PLAN COMMISSION

- a. Ryan Janssen, representing Avery & Birch, for a recommendation for Preliminary Approval of a new building consisting of a three-story salon suite facility, located at 21055 Crossroads Circle.

Strand Associates, Inc.® (Strand) has finished its third review of the plan package for the Avery and Birch Development that was received from the Town on December 28, 2023, for conformance with the Town specifications and general engineering practices. New drawings and a letter describing the revisions were returned to Strand on January 17, 2024, from Jenswold Development (Developer) after Strand's concerns from its January 8, 2024, letter were addressed (shown in the following). A third response letter with submittal was received by Strand from the Town and Developer on February 7, 2024, along with an updated Stormwater Management Plan on February 13, 2024. The most recent Developer responses are included in *italics* and Strand's current comments are in **bold**. Before construction may begin, the contractor shall submit all required permits for the development to the state, Wisconsin Department of Natural Resources, Town, and any other relevant agencies.

CONSTRUCTIO

SHEET NUMBER
C100

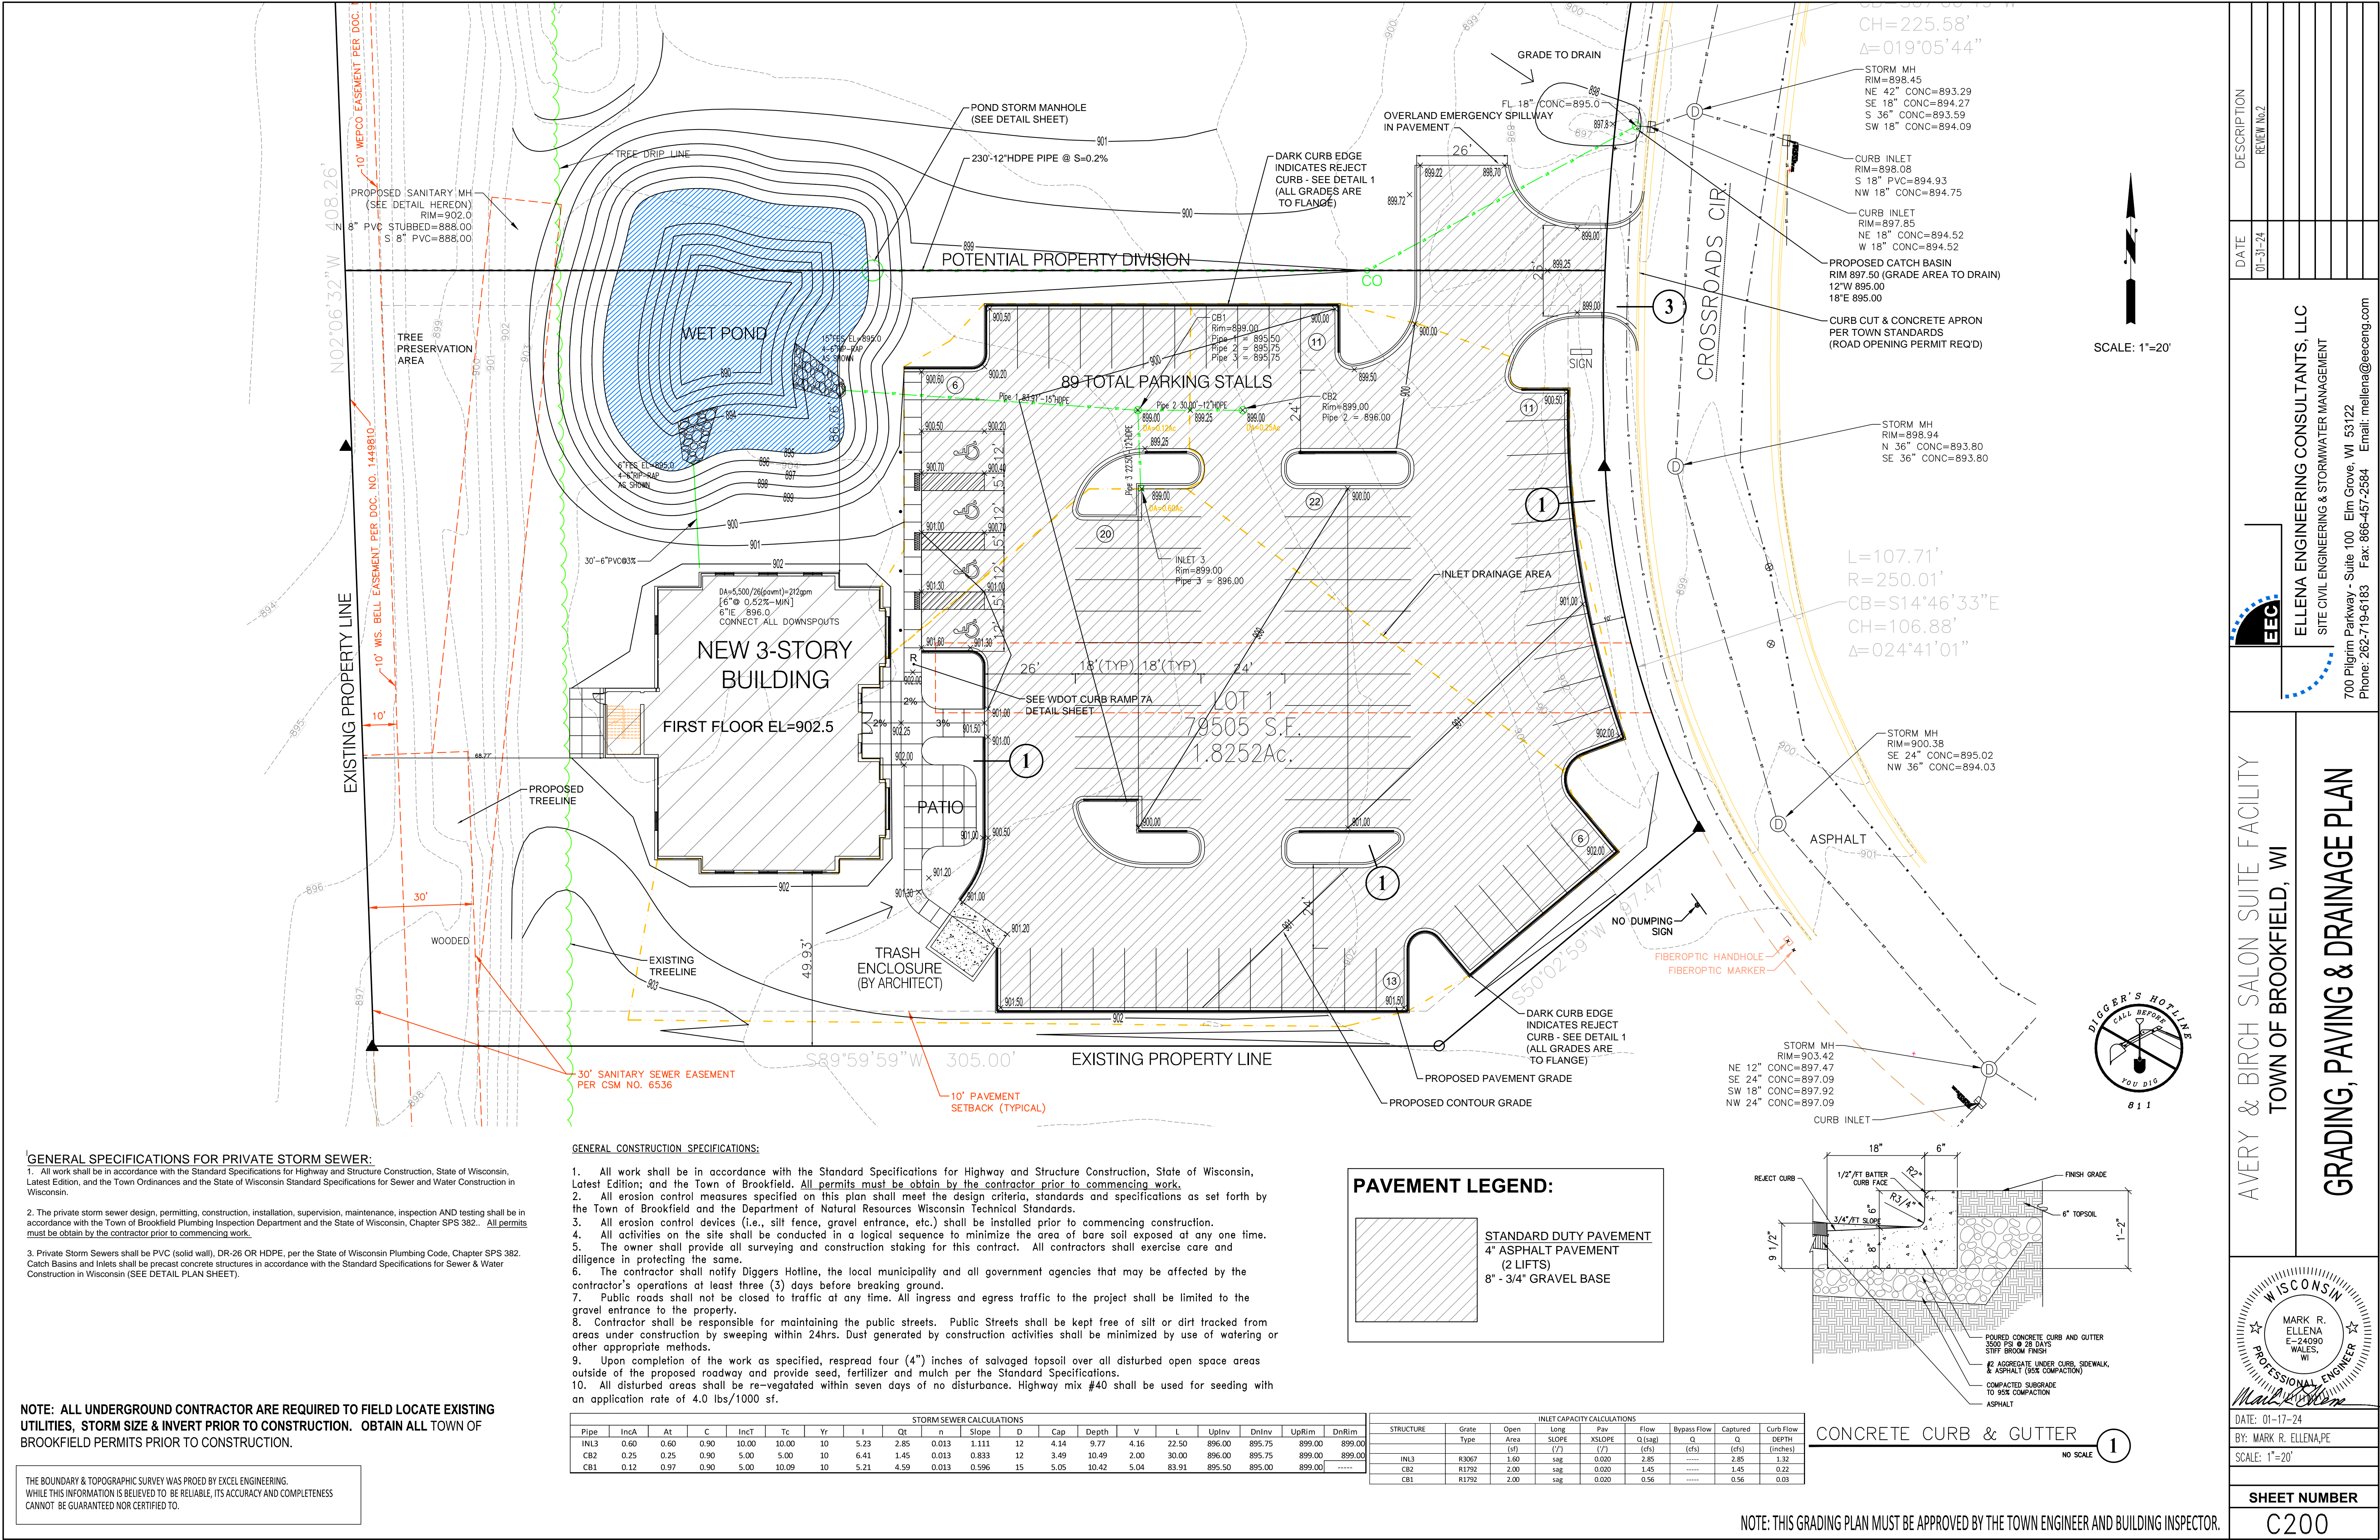
1. Strand's January 8, 2024, Comment—According to Section 17.06(3)(c)(2) of the Town Zoning Code, 2 percent of the total number of spaces shall be designated for the physically disabled. The 2010 Americans with Disabilities Act (ADA) Standards, Section 208.2, requires a minimum number of physically disabled accessible parking spaces based on the total number of parking spaces provided in the parking facility. The Town should provide direction on which standard will be enforced. There are 89 parking stalls being provided, with two stalls (2.2 percent) being ADA-accessible. The 2010 ADA standards note that a minimum of four ADA compliant stalls shall be provided if the total number of stalls ranges from 76 to 100.

Strand's January 25, 2024, Comment—The minimum dimensions for all parking spaces provided for use by physically disabled persons shall be 12 by 18 feet (Town Code 17.06(3)(c)4.). Only one ADA-compliant parking stall is meeting this requirement.

2. Strand's January 8, 2024, Comment—Calculations should be submitted showing the minimum number of parking spaces are being provided in accordance with Section 17.06(3)(h) of the Town Zoning Code.

Strand's January 25, 2024, Comment—It appears that a greater number of parking stalls will be required to meet the parking ordinance. It is recommended to add parking stalls to accommodate the one space per employee for the work shift requirement.

Strand's Current Comment—It appears that more parking stalls will be needed to account for the requirement of one space per employee for the work shift ordinance.

3. Strand's January 8, 2024, Comment—A turning moving exhibit should be provided to verify the largest vehicle (including any emergency vehicles) that will access the site can perform the required turning movements with the proposed layout.

Strand's January 25, 2024, Comment—It appears the truck used in the turning template is 30 feet long by 8 feet wide. The Town of Brookfield Fire Department requests that a WB 50 design vehicle be used for the turning template. Please update the turning template exhibit using a vehicle of this size and also show the truck is able to enter and exit the proposed driveway from Crossroads Circle.

Developer's January 17, 2024, Response—4 provided. 1 is van at 12' wide.

Developer's January 31, 2024, Response—4 stalls added at 12' wide.

Developer's January 17, 2024, Response—The proposed use is likely considered a personal service use, which requires one space per 200 square feet of gross floor area, plus one space per employee for the work shift with the largest number of employees. According to the code, 88 parking spaces are required for the square footage and the number of employees is unknown at this time.

Developer's January 31, 2024, Response—We are proposing a total of 89 stalls to meet the ordinance; 4 of which are HC compliant.

Developer's January 31, 2024, Response—Parking lot adjusted and an auto turn analysis has been prepared to address this comment using a WB-50 template.
